# UFP SITE BUILT

## MUNGO HOMES OF NC

TRUSS:	A3
JOB ID:	72439471
DELIVERY DATE:	3/7/2025
REQUESTED BY:	Parker, Jarrett
EMAIL:	jparker@mungo.com
REQUESTED ON:	3/31/2025
SUBDIVISION/MODEL:	LANGDON PRESERVE
LOT #:	17
DELIVERY ADDRESS:	84 GROVE TOWNSHIP WAY ANGIER, NC 27501
REPAIR ID:	MII-REP01A2 (ATTACHED)

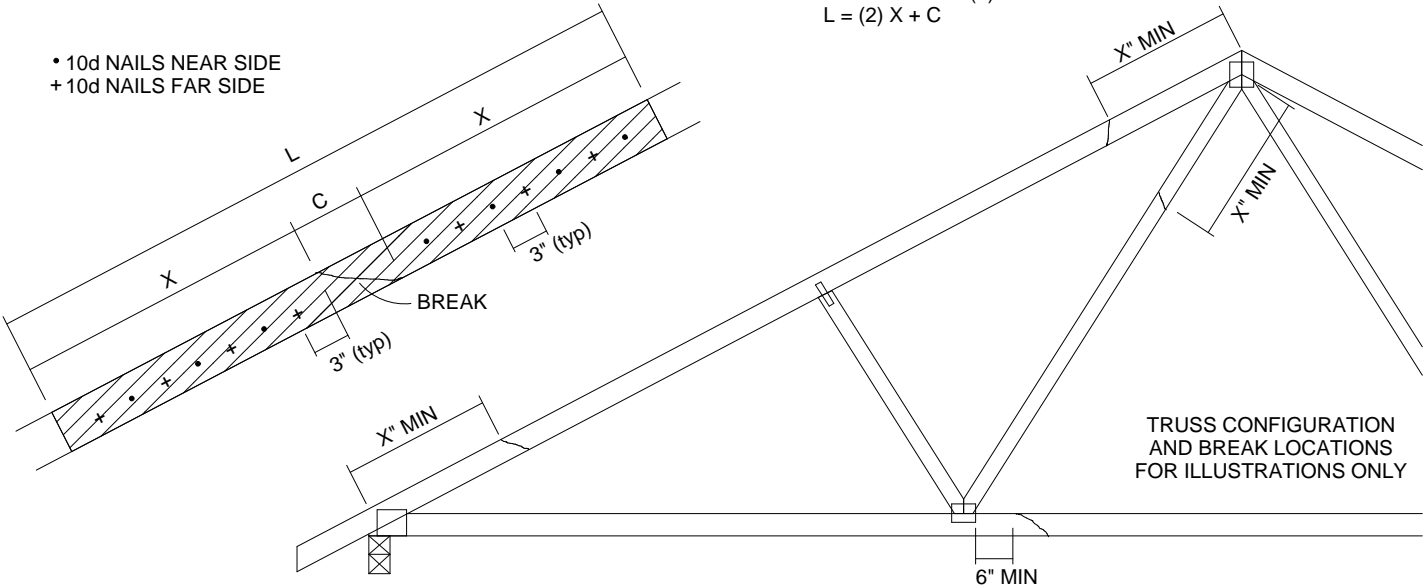
ATTACH 2x3 SCAB OF THE SAME GRADE AS THE BROKEN MEMBER TO EACH FACE OF THE TRUSS  
(CENTER ON BREAK OR SPLICE) W/CONSTRUCTION QUALITY ADHESIVE AND ONE ROW OF  
10d (0.131" X 3") NAILS SPACED 3" O.C. STAGGERED AS SHOWN.

THE LENGTH OF THE BREAK (C) SHALL NOT EXCEED 12". (C=PLATE LENGTH FOR SPLICE REPAIRS)  
THE MINIMUM OVERALL SCAB LENGTH REQUIRED (L) IS CALCULATED AS FOLLOWS:  
 $L = (2) X + C$

THE LOCATION OF THE BREAK MUST BE GREATER THAN OR EQUAL TO THE REQUIRED X DIMENSION FROM ANY PERIMETER BREAK OR HEEL JOINT AND A MINIMUM OF 6" FROM ANY INTERIOR JOINT (SEE SKETCH ABOVE)

DO NOT USE REPAIR FOR JOINT SPLICES

TOTAL NUMBER OF NAILS EACH SIDE OF BREAK *	X INCHES	MAXIMUM FORCE (lbs) 15% LOAD DURATION				
		SP	DF	SPF	HF	SPF-S
2x3		2x3	2x3	2x3	2x3	2x3
7	24"	813	748	636	644	555
9	30"	1045	962	817	828	714
11	36"	1277	1176	999	1012	872
13	42"	1510	1390	1181	1196	1031
15	48"	1742	1604	1362	1380	1190
